**Committee of Experts on the Transport of Dangerous Goods  
and on the Globally Harmonized System of Classification  
and Labelling of Chemicals****Sub-Committee of Experts on the Globally Harmonized  
System of Classification and Labelling of Chemicals****Report of the Sub-Committee of Experts on the Globally  
Harmonized System of Classification and Labelling of  
Chemicals on its twenty-seventh session**

held in Geneva from 2 to 4 July 2014

### Draft amendments to the fifth revised edition of the Globally Harmonized System of Classification and Labelling of Chemicals (ST/SG/AC.10/30/Rev.5)

Figure 2.1.3 Amend Figure 2.1.3 of the GHS by inserting the following new box in the “No” line between the boxes that read “Would the hazard hinder fire-fighting in the immediate vicinity?” and “Are there hazardous effects outside the package?” as follows:

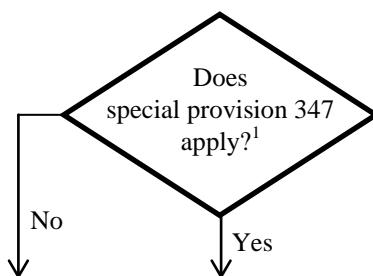
Insert a footnote under the flowchart to read as follows:

<sup>1</sup> See Chapter 3.3 of the UN Recommendations on the Transport of Dangerous Goods, Model Regulations for details.”.
